Philco Radio & Television Corp.

MODEL 89,19
Schematic
Alignment
Changes

Models 89 and 19

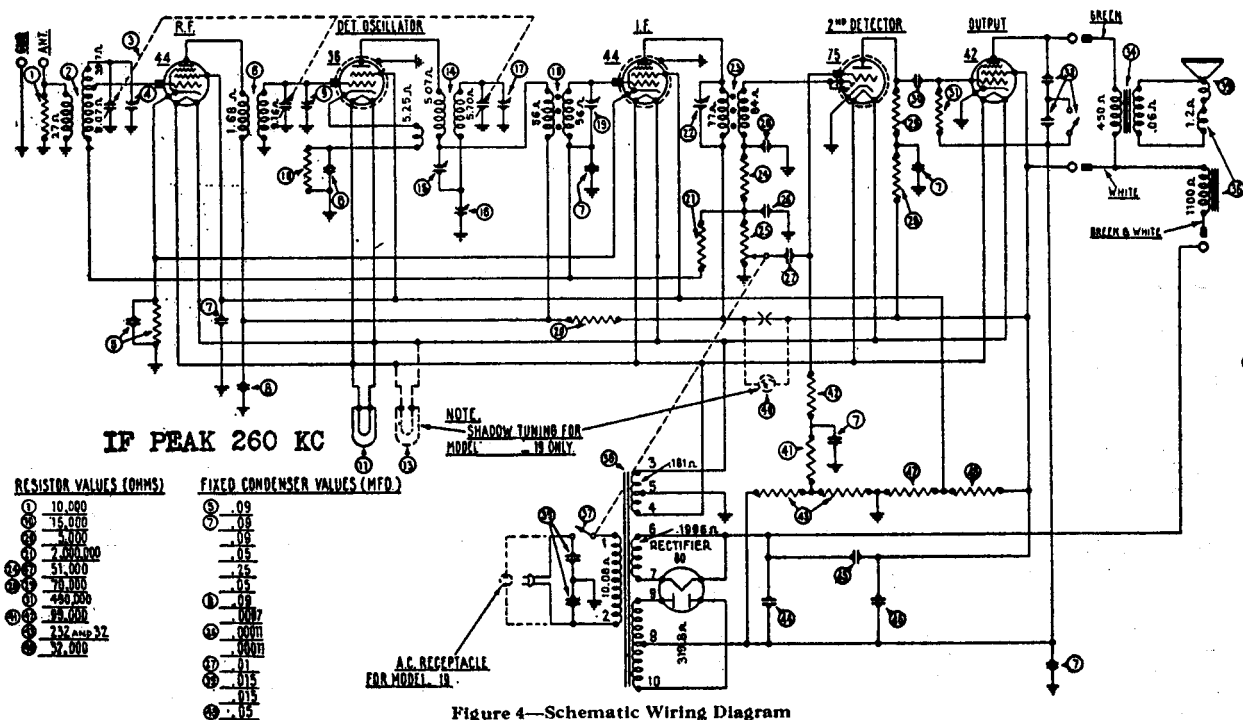
In run number 5; the antenna coil ③ part number 06619 was changed to new coil part number 32-1062. The interstage coil ④ part number 06662 was changed to new coil part number 32-1063. The volume control and A. C. switch ⑤ part number 33-5004 was changed to new Volume Control (only) part number 33-5007. A combined "On-Off" and frequency change switch was added, part number 42-1002. The above changes permits the police and airplane broadcast reception.

In run number 2, Model 19-121; run number 3, Model 19-122; a (2900 ohms) resistor, part number 5309 was added. This resistor was connected between ③ condenser, lug No. 3 to lug No. 5 on the condenser mounted between ② antenna transformer and the R. F. socket.

Below run number 4 on 89-121; run number 1 on 19-121; run number 2 on 19-122, the wiring on the compensating condenser ⑨ was reversed and the fibre nut, part number 7505 was changed to part number 3151 (brass nut); part number W-775 hole cover was added.

Use ⑩ power transformer part number 8047. Change ⑪ electrolytic condenser (6 mfd.) part number 8165 to new condenser (8 mfd.) part number 7558. Change ⑫ electrolytic condenser (6 mfd.) part number 8166 to new condenser (8 mfd.) part number 7558.
